SUBJECT: SEQUOYAH NUCLEAR PLANT, UNITS 1 AND 2 - STAFF ASSESSMENT OF INFORMATION PROVIDED PURSUANT TO TITLE 10 OF THE *CODE OF FEDERAL REGULATIONS* PART 50, SECTION 50.54(f), SEISMIC HAZARD REEVALUATIONS RELATING TO RECOMMENDATION 2.1 OF THE NEAR-TERM TASK FORCE REVIEW OF INSIGHTS FROM THE FUKUSHIMA DAI-ICHI ACCIDENT (TAC NOS. MF3767 AND MF3768)

STAFF ASSESSMENT BY THE OFFICE OF NUCLEAR REACTOR REGULATION

RELATED TO SEISMIC HAZARD AND SCREENING REPORT

SEQUOYAH NUCLEAR PLANT, UNITS. 1 AND 2

Figure 3.3- 1 Plot Comparing the Staff's and the License's Median Amplification Functions and Uncertainties for the Sequoyah site

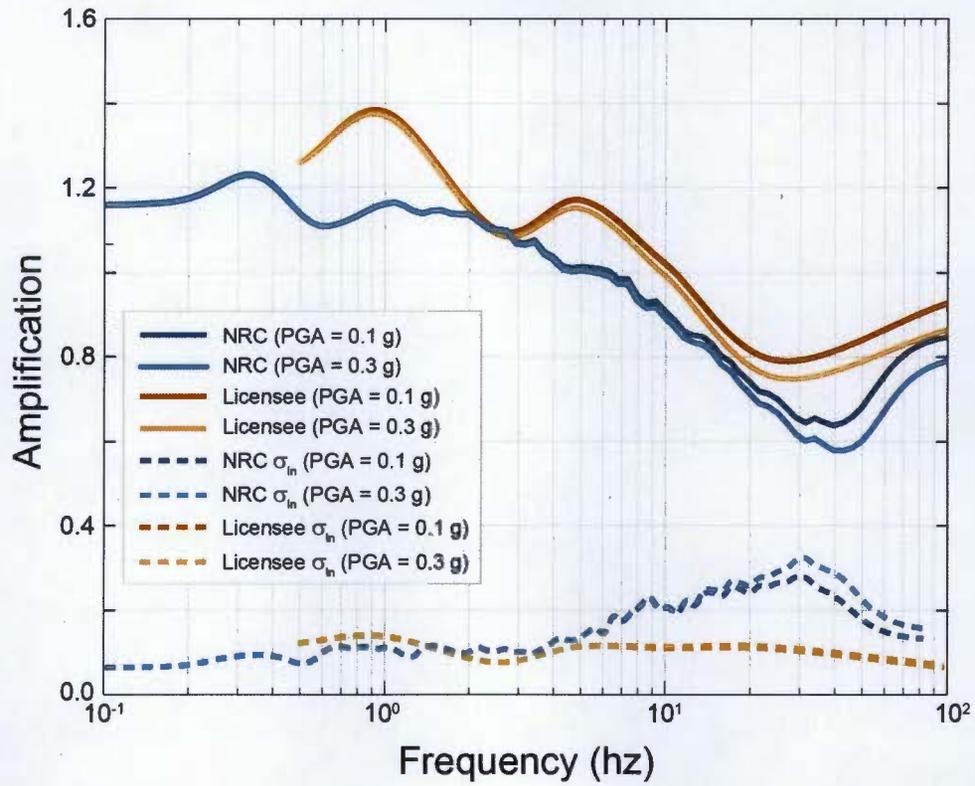
Figure 3.3-2 of this assessment shows a comparison of the staff's and the licensee's median site amplification functions and uncertainties for two of the eleven input loading levels. As shown in this figure, the licensee's amplification functions are somewhat higher than those of the staff's. These small differences in the amplification functions reflect the minor differences in the site response analyses performed by the staff and the licensee. These small differences are within the limits of uncertainty and as such judged by the staff to be reasonable.

Figure 3.3-2 Plot Comparing the Staff's and the Licensee's Mean Control Point Hazard Curves at a Variety of Frequencies for the Sequoyah site

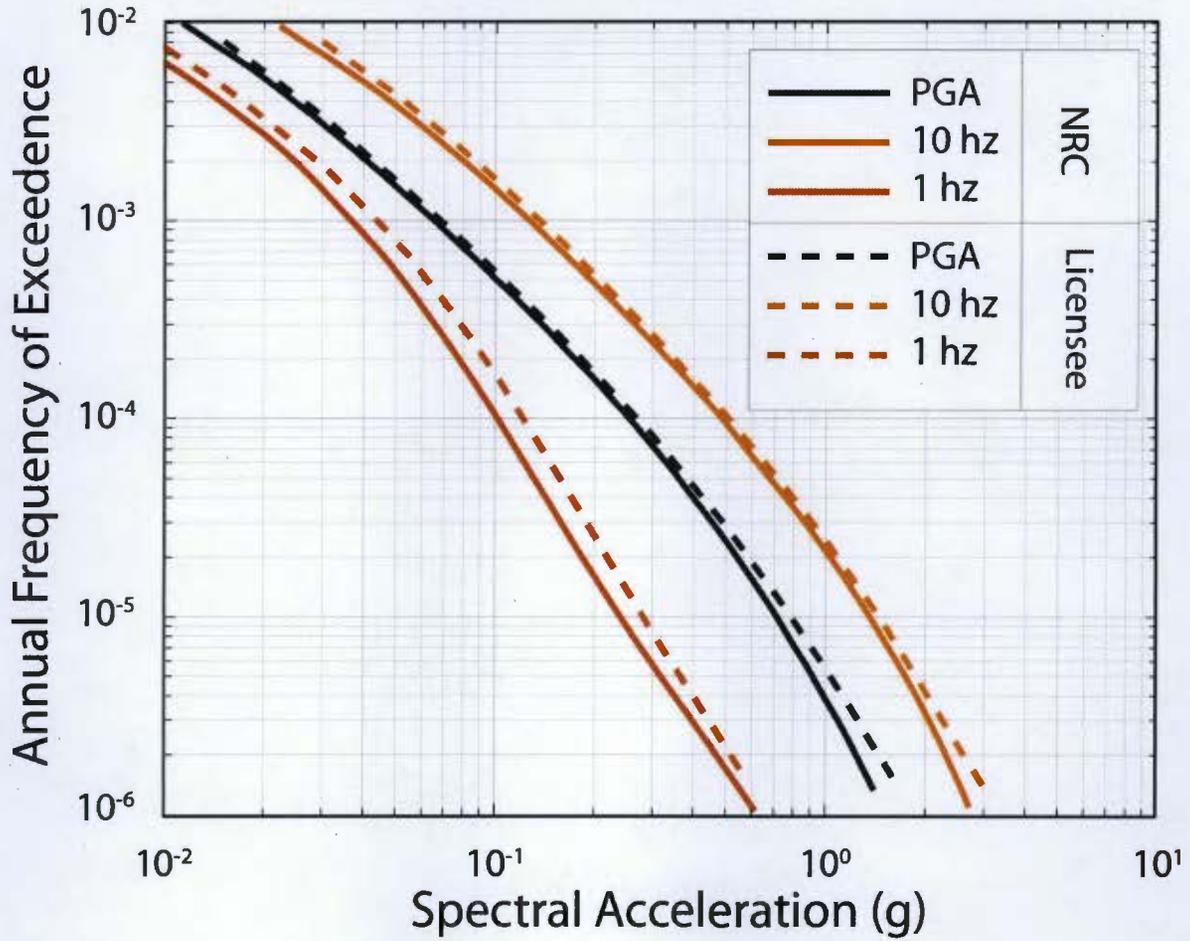
Overall, the licensee's approach to modeling the subsurface rock properties and their uncertainty, results in similar site amplification factors with slight differences. As shown in Figure 3.3-3 of this assessment, the control point hazard curves of the licensee and NRC at 1 Hz, 10 Hz, and PGA

are very similar, with licensee's slightly higher at all frequencies. Appendix B of the SPID provides guidance for performing site response analyses, including capturing the uncertainty for sites with less subsurface data; however, the guidance is neither entirely prescriptive nor comprehensive. As such, various approaches in performing site response analyses, including the modeling of uncertainty, are acceptable for this application.

Figure 3.4-1 Comparison of the Staff's GMRS, Licensee's GMRS, and the SSE for the Sequoyah site

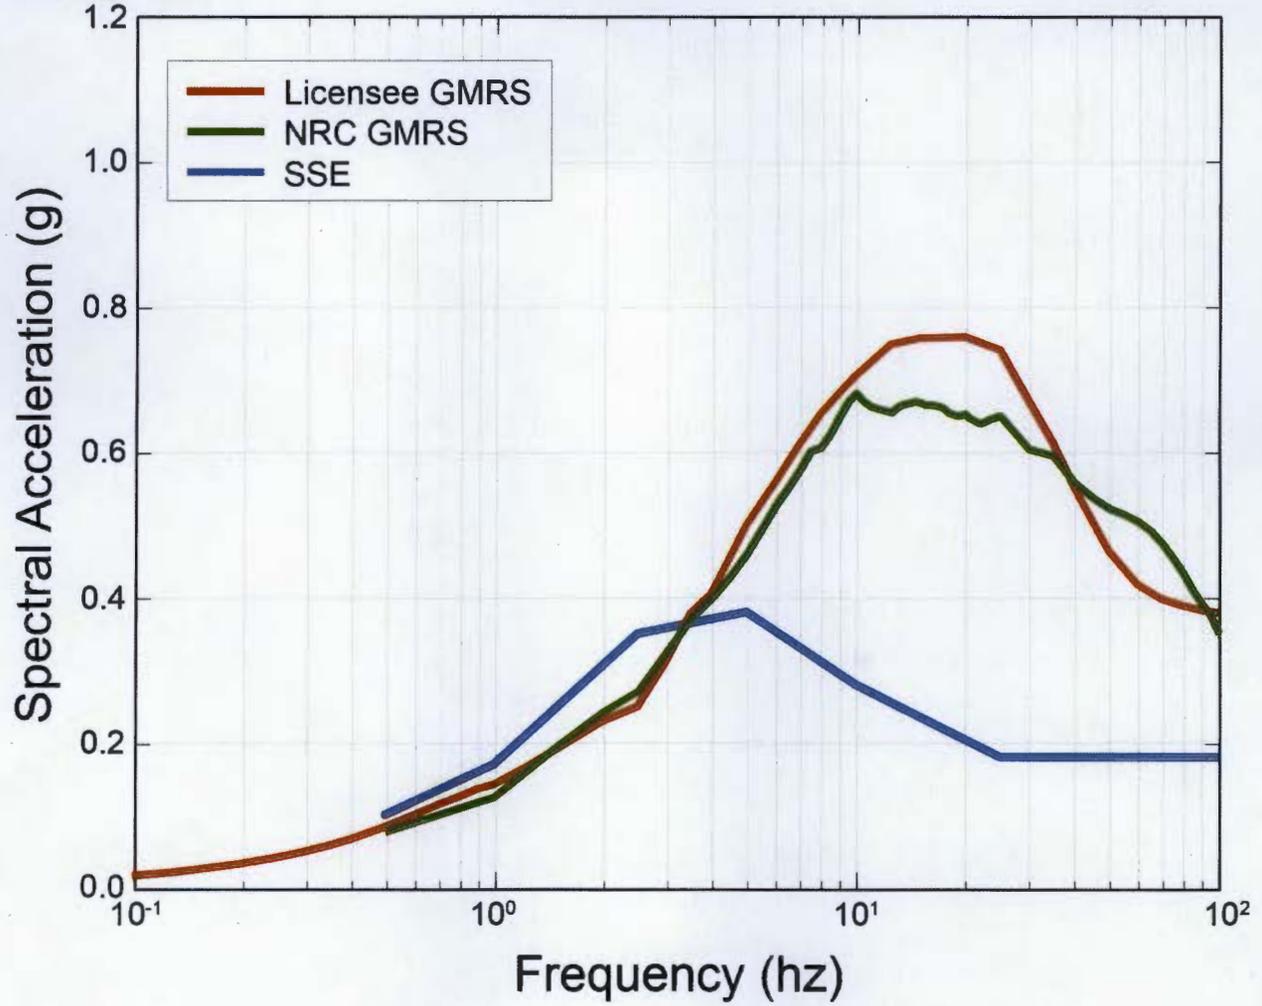
The staff independently calculated the 10^{-4} and 10^{-5} UHRS using the results of its confirmatory PSHA and site response analyses, as described in Sections 3.2 and 3.3 of this assessment, respectively. Figure 3.4-1 of this assessment shows a comparison of the GMRS determined by the licensee to that determined by the staff.

As shown in Figure 3.4-1, the licensee's GMRS shape is generally similar to that calculated by the staff at frequencies less than 10 Hz. However, NRC staff's confirmatory GMRS is somewhat lower than the licensee's in the 10-35 Hz range, and slightly higher above 40 Hz. As described in Section 3.3 of this assessment, the staff concludes that these minor differences over the higher frequency range are primarily due to the differences in the site response analyses performed by the licensee and staff. The staff concludes that these differences are acceptable because the licensee followed the guidance provided in the SPID with respect to both the PSHA and site response analysis for the Sequoyah site.
